Technical Service Bulletin:

Condensate Trap – Manufacturing Error

Models: Bosch BGH96 (96% Condensing Gas Furnace) – All Sizes

Figure 1

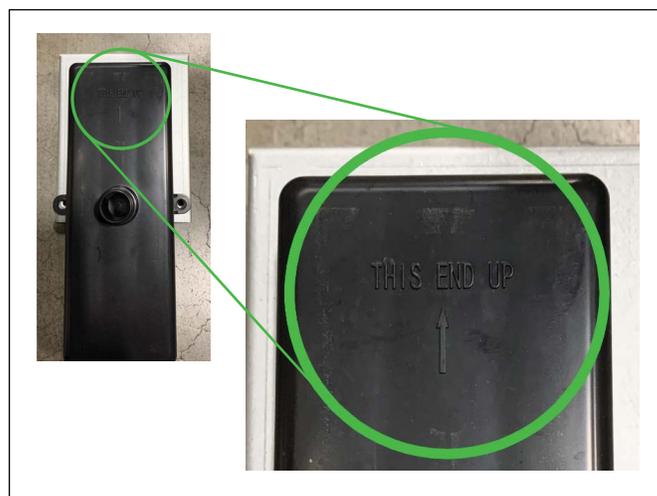
1. On all of the condensate traps you will see an arrow and “This End Up” at one end of the front surface. The notice is in black, so it can be difficult to see (see Fig.1).

Figure 2

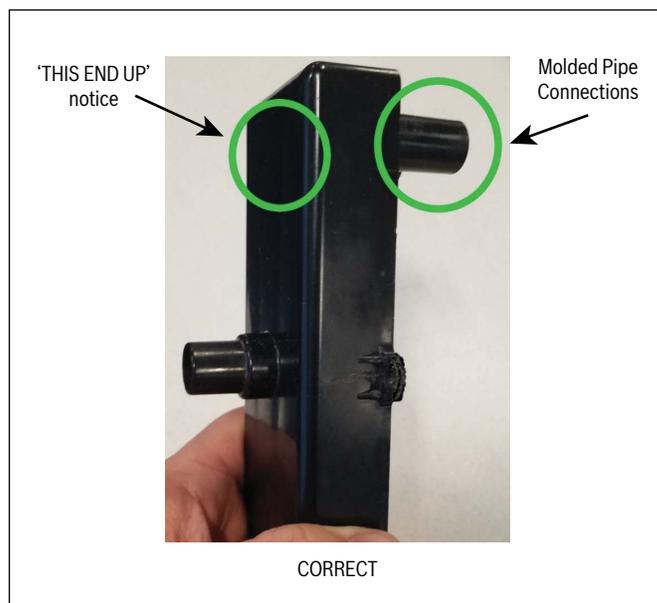
2. A **correctly** manufactured condensate trap has a pair of molded pipe connections on the reverse side of the trap at the same end as the “This End Up” notice (see Fig.2).

- ▶ If you have a correctly manufactured condensate trap installed, no further action is needed. You can reinstall the component back into the furnace and return it to operation.
- ▶ If you have an incorrectly manufactured condensate trap, it must be replaced with a correct part before the furnace is put back into operation. Please contact our technical support team* at 1-800 283 3787, or via email at furnace.techsupport@us.bosch.com, and our technicians will arrange for a new condensate trap to be shipped to you.

Figure 3

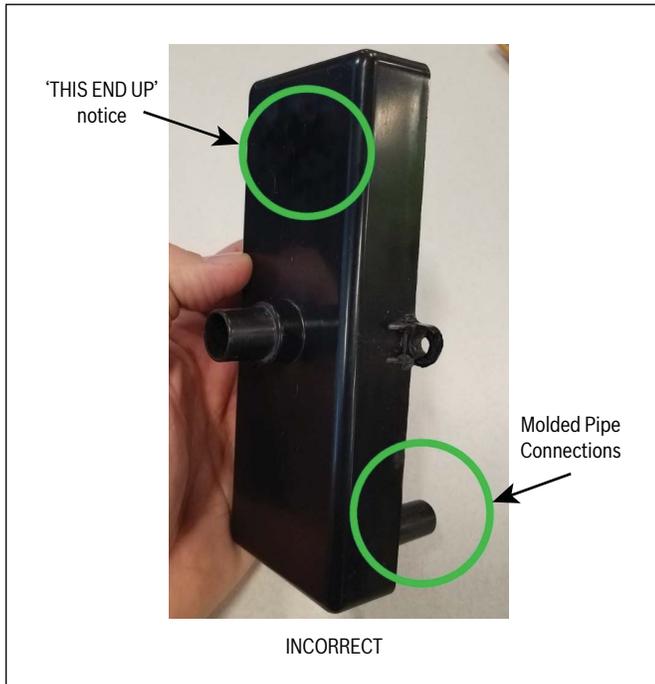
3. On an **incorrectly** manufactured condensate trap, the pair of molded pipe connections are at the opposite end of the trap from the "This End Up" notice (see Fig.3).
